Agenda Item # 11

SUB-002846-2024 & ZON-UDC-002848-2024

The Mobile Commerce Park Subdivision, Phase 1,
Resubdivision of Lots 16 & 17

Proposal:

SITE PLAN

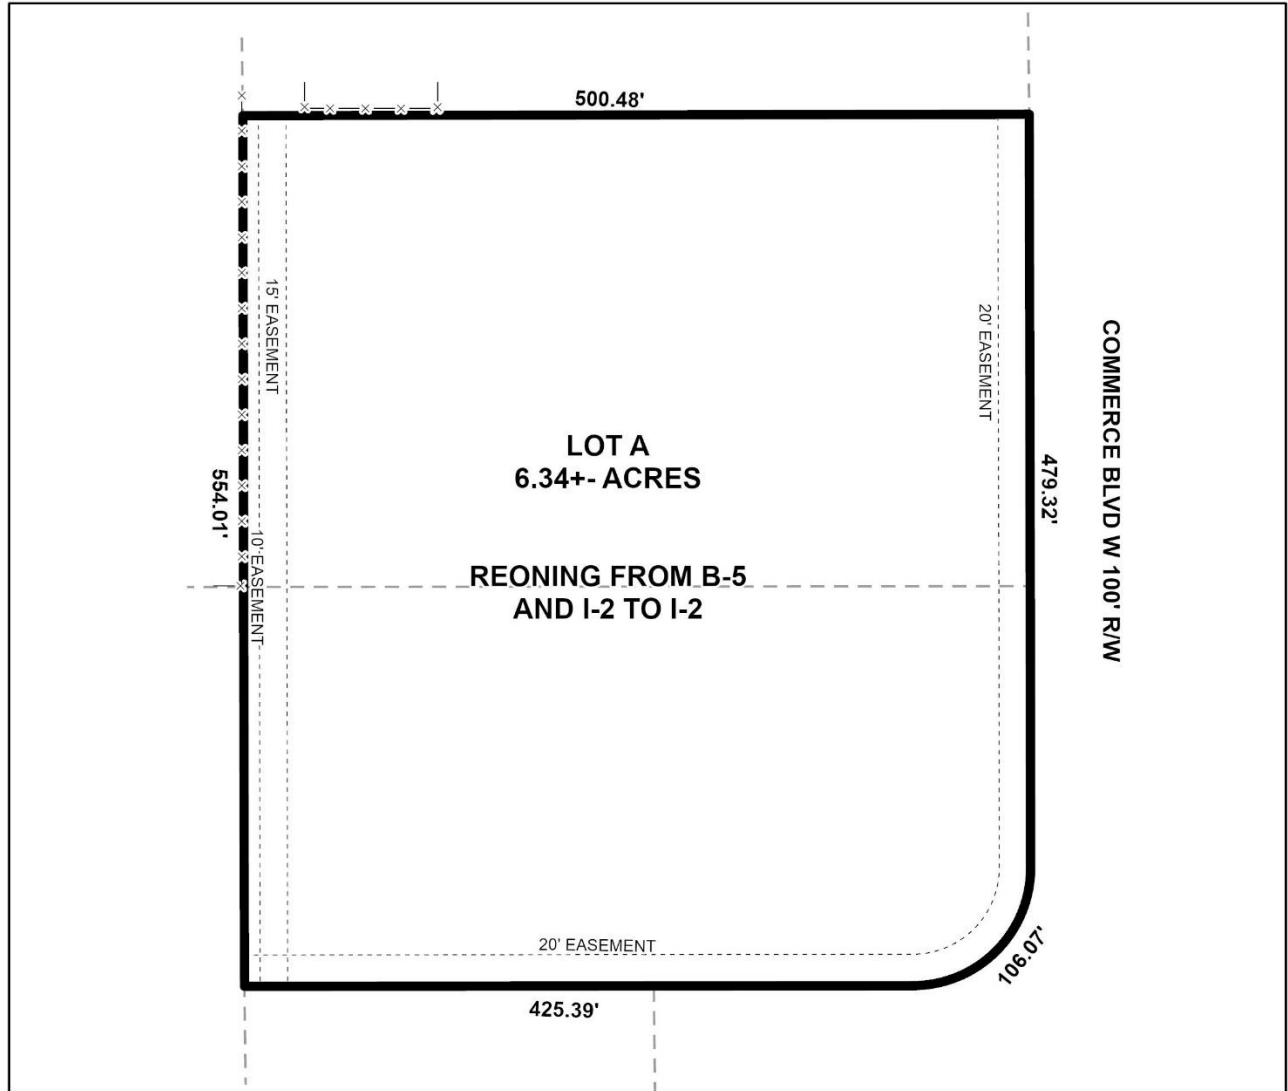
The site is a corner lot with frontage along Commerce Boulevard West, a minor street with curb and gutter typically requiring a 50-foot right-of-way; however, the Preliminary Plat illustrates a 100-foot right-of-way, and is consistent with plats previously recorded for Mobile Commerce Park Subdivision Phases I and II. As such, if approved, no additional dedication should be required.

The Preliminary Plat does not illustrate front yard setbacks as required by Section 6.C.8. of the Subdivision Regulations. As such, if approved the Final Plat should be revised to illustrate a 25-foot front yard setback along all frontages, in compliance with Article 2, Sections 4-2-16.E and 64-2-22.E of the UDC for lots in the B-5 and I-2 districts, respectively.

The proposed lot exceeds the minimum size requirement for lots served by public water and sanitary sewer in B-5 and I-2 zoned districts. However, the lot area is not labeled with its size in both square feet or acres. If approved, the lot size should be provided on the Final Plat in both square feet and acres, or a table should be furnished on the Final Plat providing the same information.

The Preliminary Plat illustrates multiple easements on the site, which should be retained on the Final Plat, if approved. Additionally, if approved, a note should be included on the Final Plat stating that no structure may be constructed or placed within any easement without the permission of the easement holder.

Lot 17, Mobile Commerce Park Phase 1 is currently zoned B-5, Office Distribution District, and the adjacent Lot 16, Mobile Commerce Park Phase 1 is currently zoned I-2, Heavy Industry District. As proposed, Lot A would combine the two properties; therefore, the proposed rezoning from B-5 to I-2 for proposed Lot A should be completed to eliminate split zoning before the Final Plat can be signed.

1. Provision of the lot size labels in both square feet and acres, or the furnishing of a table on the Final Plat providing the same information;
2. Retention of the right-of-way width on the Final Plat;
3. Revision of the Final Plat to illustrate a 25-foot minimum building setback line along all frontages;
4. Placement of a note on the Final Plat stating that no structures are allowed in any easement without permission of the easement holder;
5. Completion of the Rezoning process from B-5 to I-2 for proposed Lot A prior to signing the Final Plat;
6. Compliance with all Engineering comments noted in this staff report;
7. Placement of a note on the Final Plat stating all Traffic Engineering comments noted in this staff report;
8. Compliance with all Urban Forestry comments noted in this staff report; and,
9. Compliance with all Fire Department comments noted in this staff report.
